AMENDMENTS TO THE DRAWINGS

10/637,199

LMP128US

Fig. 3

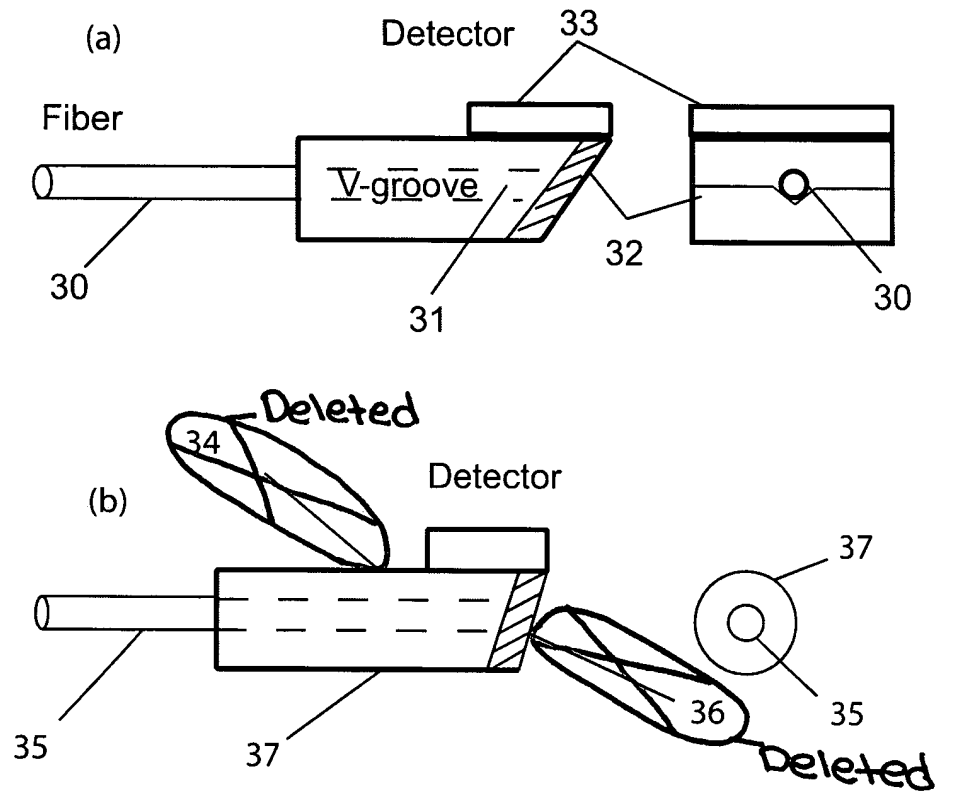
The changes to Figure 3(b) include the deletion of reference numbers 34 and 36.

The drawings have been objected to because numeral 56 in Figure 5(a) does not point to any feature. Figure 5(a) has been corrected as suggested by the Examiner. Reference numerals 34 and 36 have been removed from Figure 3(b) since these numerals are not discussed in the specification. Two replacement sheets and two sheets showing changes accompany this paper.

Fig. 5

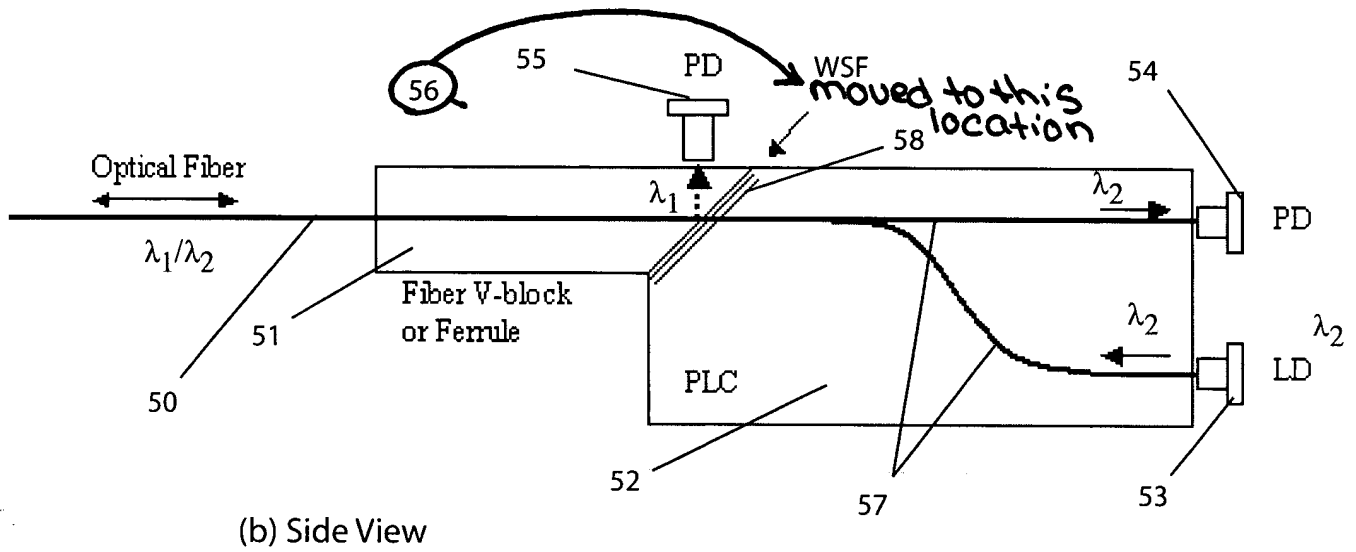
The changes to Figure 5(a) include the repositioning of reference number 56.
